Preliminary Plan - R-15

Reece Road Community

PETITION NO: Z-9

PLANNING COMMENTS:

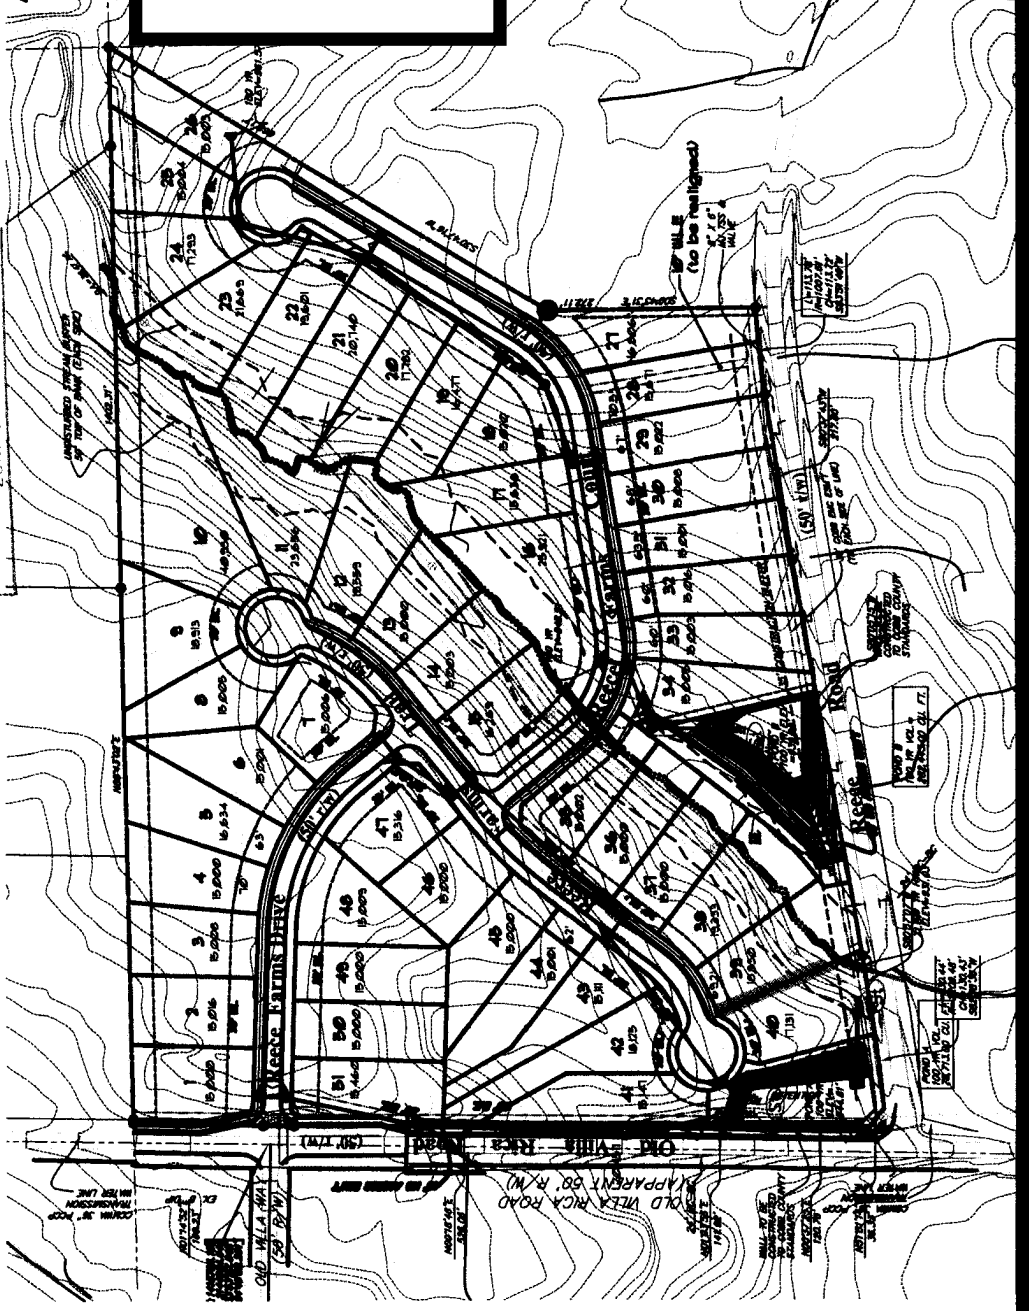
The applicant is showing contemporaneous variances which are:

1. Reduce the lot width from 75-feet to as small as 60-feet on 9 lots (lots shown on the plan).
2. Reduce the front setback from 35-feet to 20-feet, for 14 lots shown on the plan (Note: Variance V-48 of 2006 was approved to reduce the front building setback to 20-feet for 11 lots).

- No Stormwater controls shown
Copy of survey is not current - Additional comments may be forthcoming when current site conditions are exposed.
No site improvements showing on exhibit.

- 1. The hydrology study for this development must be revised to verify that adequate stormwater management is provided for the increased lot density. As-built surveys of the existing ponds may be required to verify that adequate storage has been provided.
2. The existing discharge headwall from Pond A located adjacent to Reece Road may need to be extended closer to the receiving stream or an adequate flowpath created to keep pond discharges from flowing directly across the Reece Road R/W to the roadway.
